RECORD OF TECHNICAL CHANGE

Technical Change No. CAJP-1Page 1 of 2Project/Job No. JS03-430Date 11/30/04Project/Job Name Corrective Action Investigation Plan for CAU 543: Liquid Disposal Units

Applicable Project-Specific Document(s): Corrective Action Investigation Plan for Corrective Action Unit 543: Liquid Disposal Units, Nevada Test Site, Nevada, Revision 0, May 2004.

Figure A.1-8
CAU 543, CAS 06-07-01, Potential Decision I Sample Locations

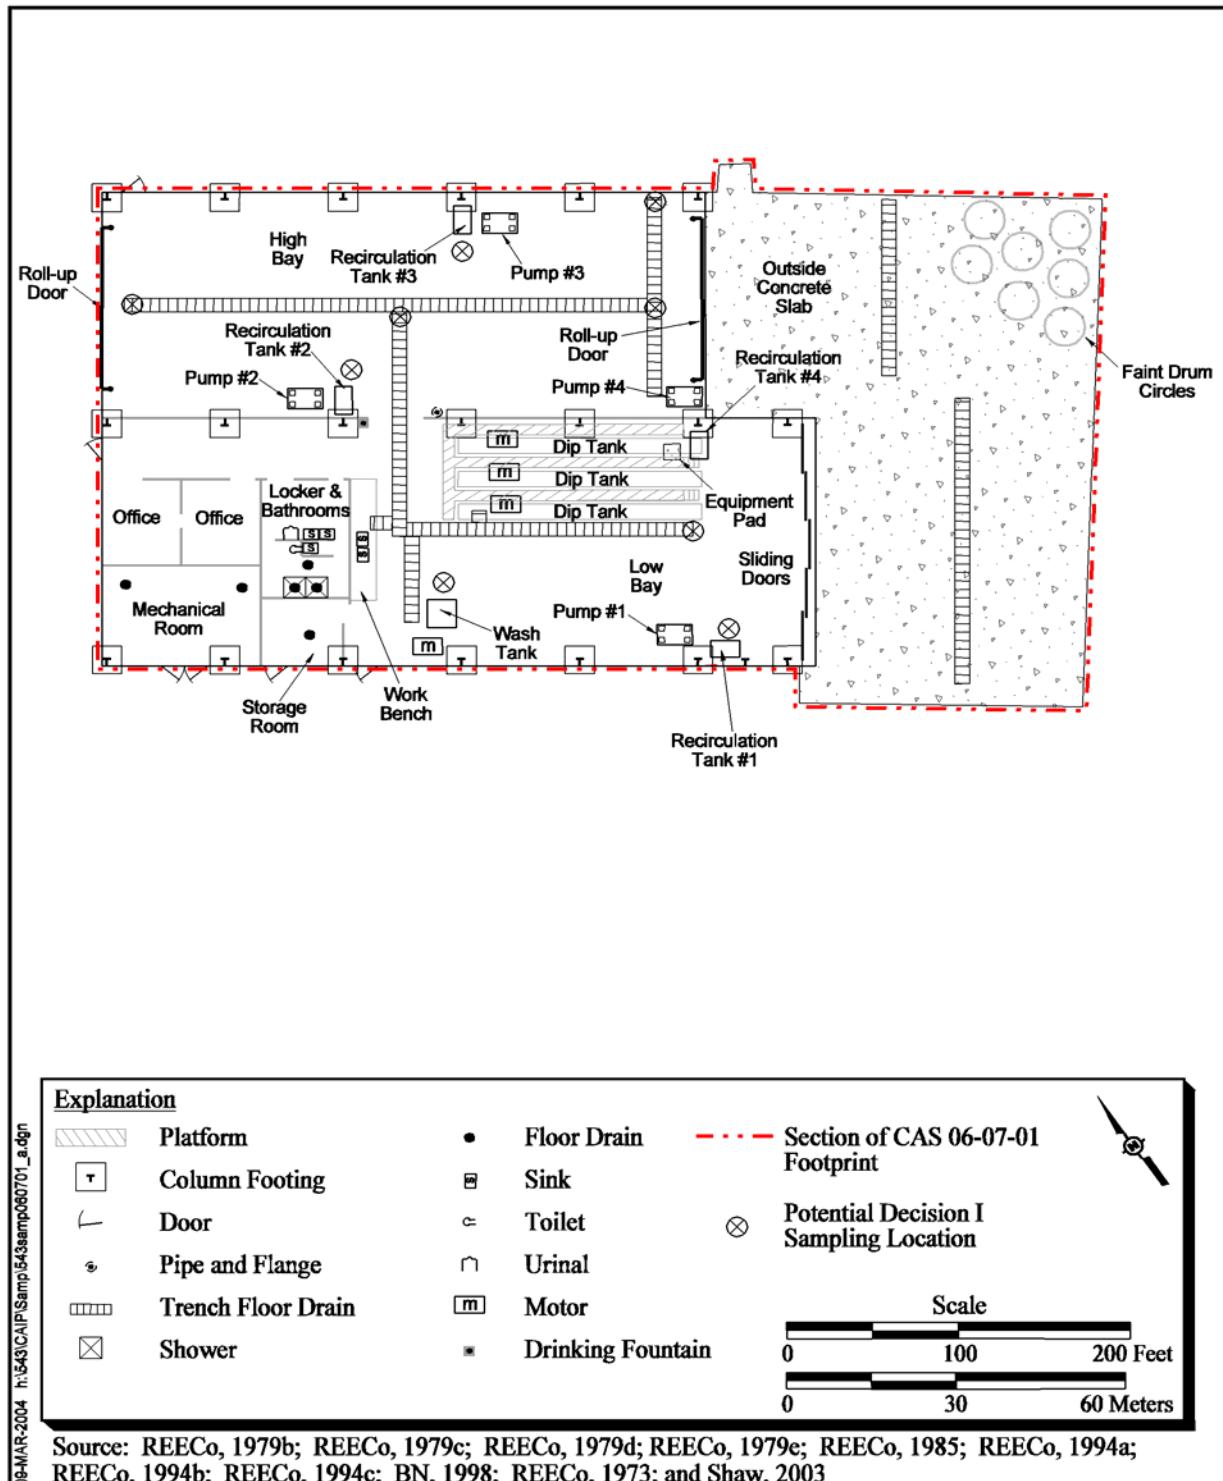
Section A.1.8.2.1, Building 6-605 subsection, Page A-54, 1st full paragraph. Replace the paragraph with the following, "All remaining drains, trenches, and piping within the Building 6-605 foundation slab will be inspected for residual sediments/materials not removed during the demolition. If residual material is present, Decision I samples will be collected. If biasing factors indicate the need, concrete from the floor may be scabbed and submitted for analysis. It is expected that the nature of Decision I sampling will most likely provide sufficient information on the extent of contamination for Building 6-605 so that Decision II sampling may not be necessary. See Figure A.1-8 for proposed sample locations."
